From: Joshua D. Hoffman <JHoffman@Pennoni.com>
Sent: Thursday, July 27, 2023 12:10 PM
To: Dresch, Justin; Miller, Matthew
Cc: Daniel Ahn
Subject: RE: [External] FW: PAD390265

From: Dresch, Justin <jdresch@pa.gov>
Sent: Thursday, July 27, 2023 11:38 AM
To: Joshua D. Hoffman <JHoffman@Pennoni.com>; Miller, Matthew <majmiller@pa.gov>
Cc: Daniel Ahn <dahn@lehighconservation.org>
Subject: RE: [External] FW: PAD390265

Subject: PAD390265

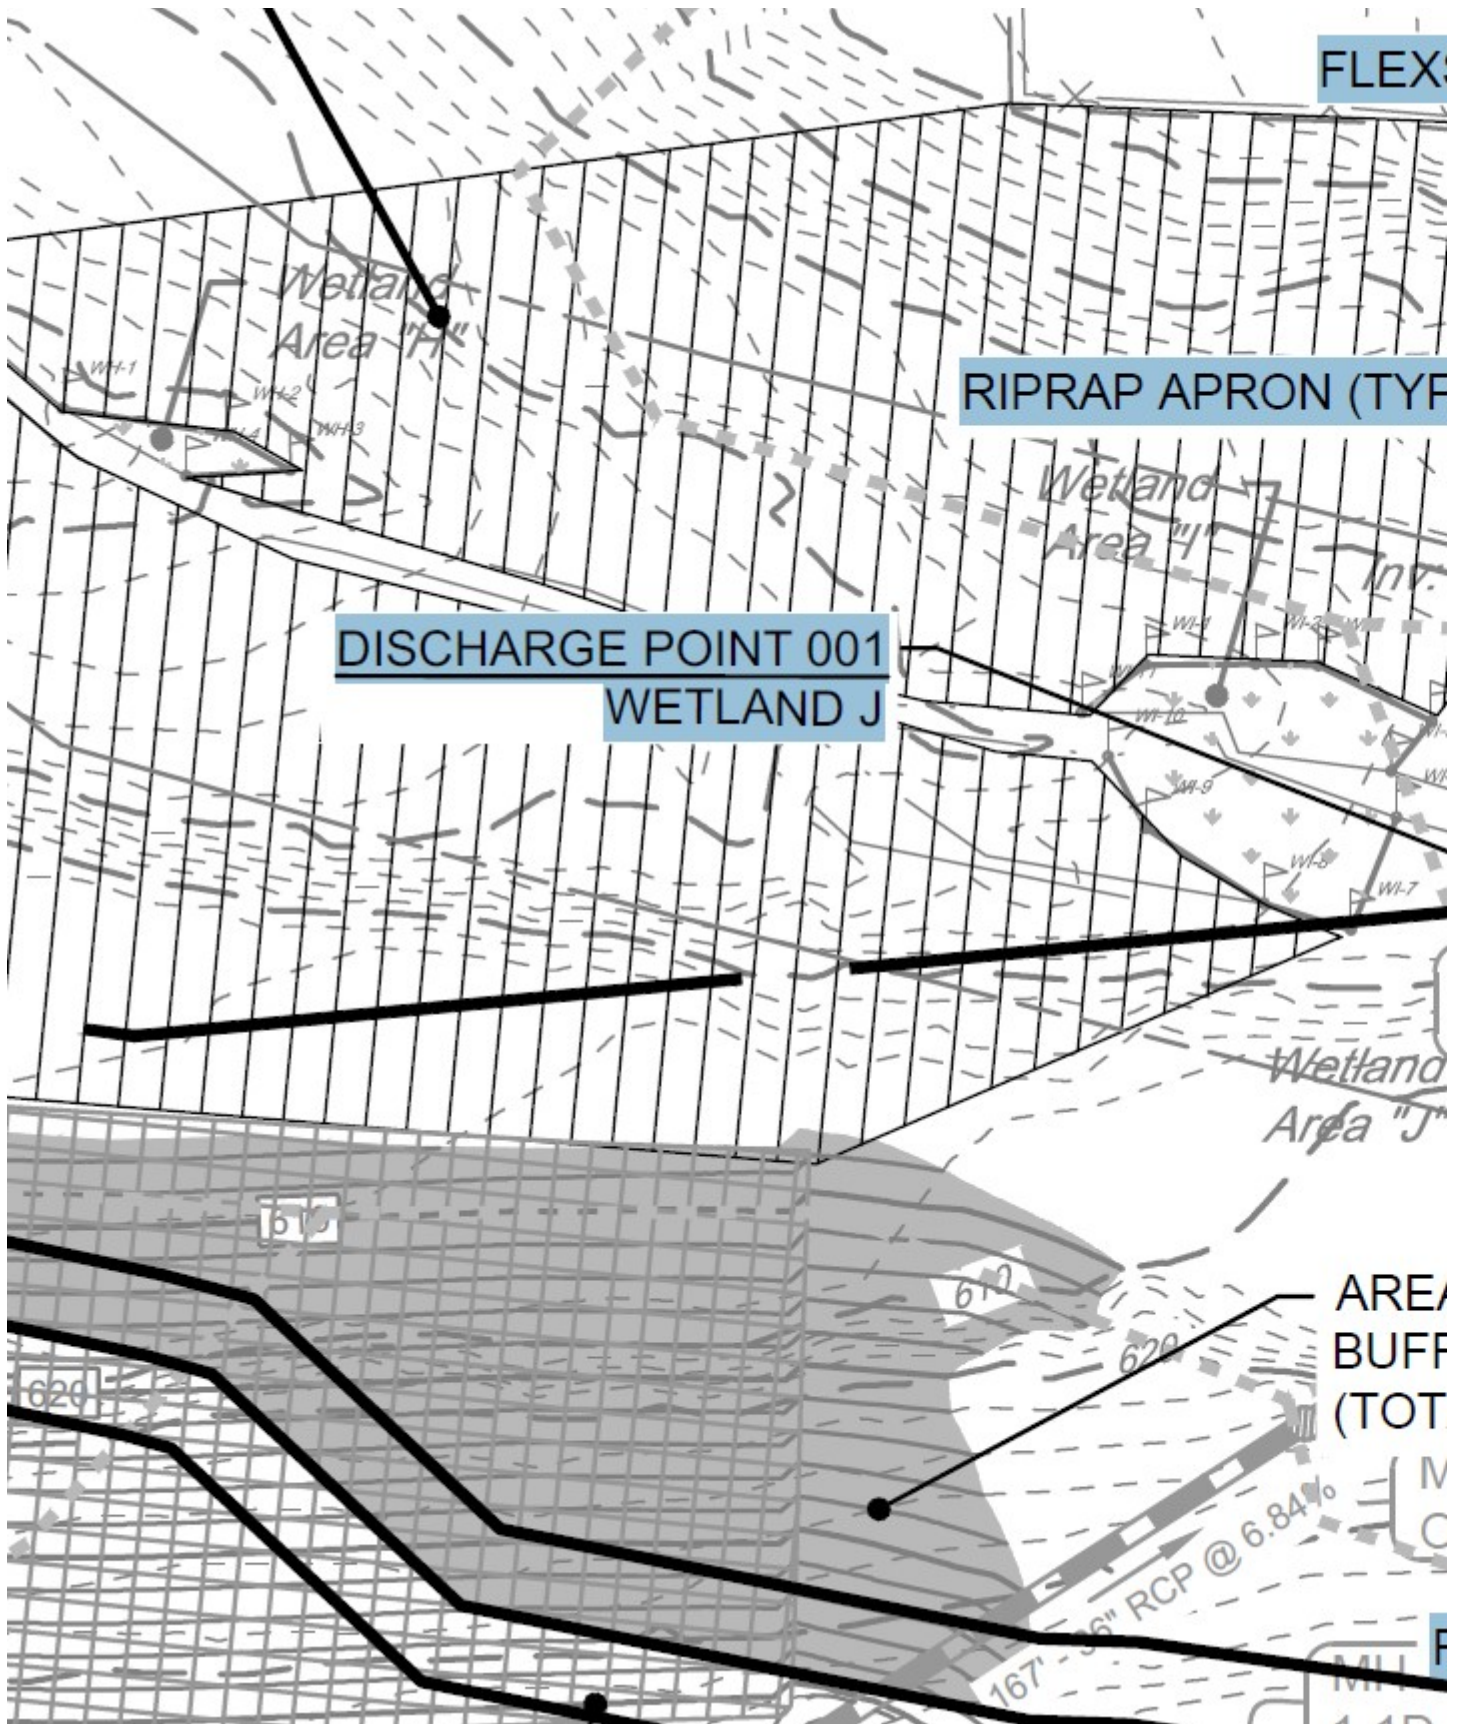
Yes, this is the area that the Conservation District referenced. This existing UNT is being fed by and upstream existing stormwater management facility which we are removing and providing a larger one to the same discharge point. The UNT only starts just downstream of the existing wetlands so we have provided an assumed 50' floodway boundary for the UNT on the plan. I'm not sure if the upstream area to the stream is technically within the 50' assumed floodway or not but that is our scenario here. We are not impacting any streams or wetlands as part of our project. Please let us know what needs to be done moving forward here. Thanks.

I apologize for the late response to your inquiry. Is this the area that Lehigh CCD is referring to in their technical comment letter? If so, it appears as though two (2) stormwater outfalls are proposed within the floodway an UNT of Jordan Creek. These outfalls would be regulated by DEP, but would seem to qualify for a "Waiver of Permit Requirements" due to the fact that the contributory drainage area associated with the stream at the location of the outfalls appears to be less than 100 acres in size. Are there any other impacts to the stream being proposed?

Thanks, Josh. Any stormwater outfalls or cuts, fills, or earth disturbance within the 50-ft (assumed) floodway of this stream would qualify for a waiver and no further correspondence with DEP would be necessary. Examples of activities which are not waived would be stream enclosures, channel changes, fill within the bed/banks of the stream, activities which impact wetlands, dredging within the stream, etc.
